Lime Down Solar Park

**Planning Inspectorate Reference:
EN010168**

**Wiltshire Council Responses to Action Points
Arising from the Hearings**

Deadline 7 (2 October 2026)

Fosse Way (SOUTH) - West Dunley Cottages to Railway Bridge

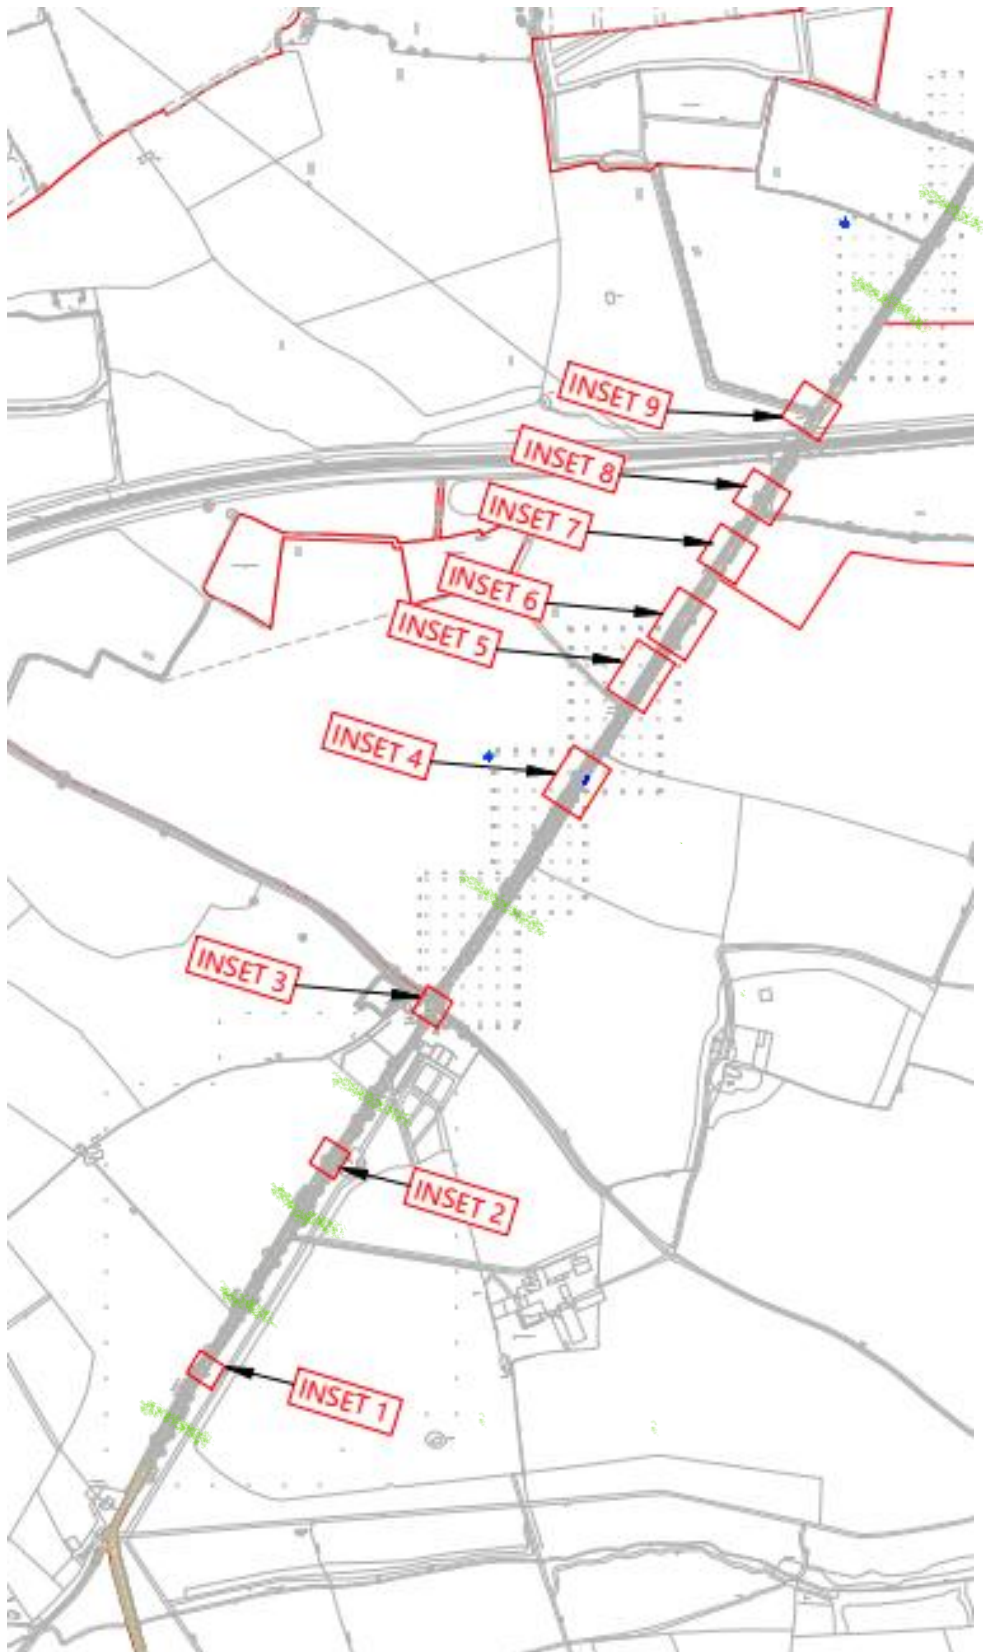
2.2. The additional HGV passing place provision, which the council considers is required pre-construction, are illustrated by the Green Lines on these plans.

Additional HGV Passing Place Provision - Pre-Construction – WC View (Green lines)
